TELSTRA LIMITED

Draft allocation and technical instruments for the 3.4/3.7 GHz bands auction

Public submission

29 March 2023

Figure 1 – Comparison of ACMA and FCC Filter characteristics where F = 3820 MHz

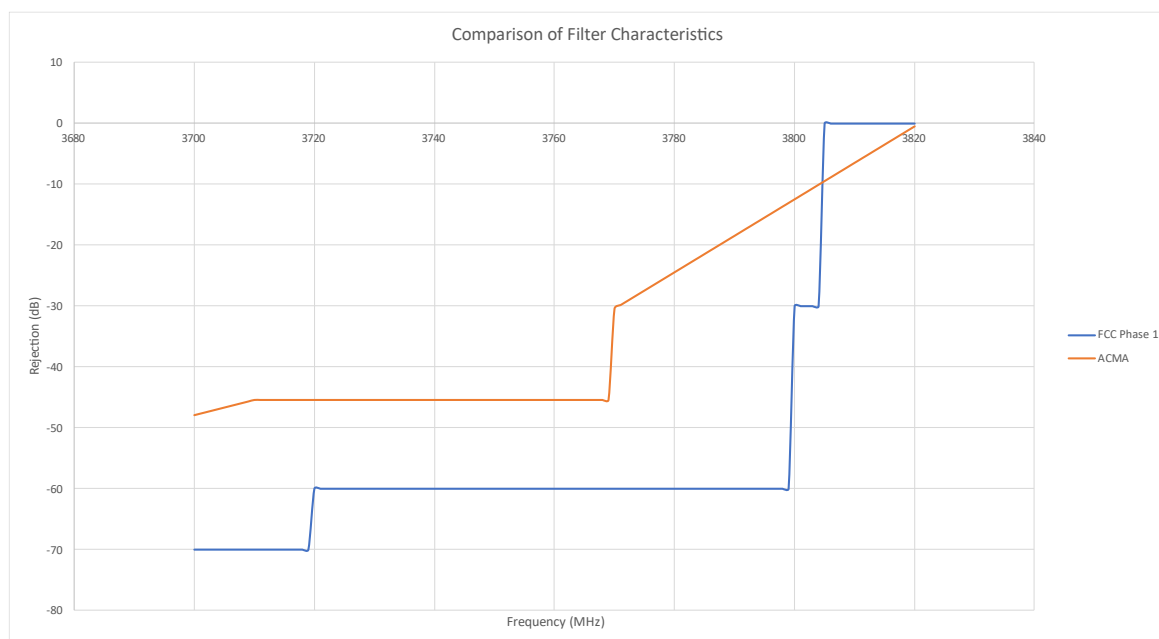
We reiterate our position expressed during the TLG process that the attenuation performance of the RF filter detailed in Table 1 of clause 4.3 (also in table 8 of RALI MS47 for AWLs) is inadequate. We strongly recommend that it be revised to an equivalent of the filter parameters that were proposed by the C-Band Alliance industry group in North America⁸ and which were adopted by FCC in Docket No. 18-122 'Expanding Flexible Use of the 3.7 to 4.2 GHz Band'.⁹

A plot showing the current the ACMA filter mask compared to the new FCC filter mask is shown in Figure 1.

We therefore recommend Table 1 of clause 4.3 (as well as Table 8 of RALI MS47 for AWLs) in the Transmitter RAG be amended to specify a filter mask that is aligned with that detailed in the FCC 2020 ruling and that the filter mask should apply to frequencies below 3820 MHz similar to that proposed for the FCC Phase 1 Clearance Plan.
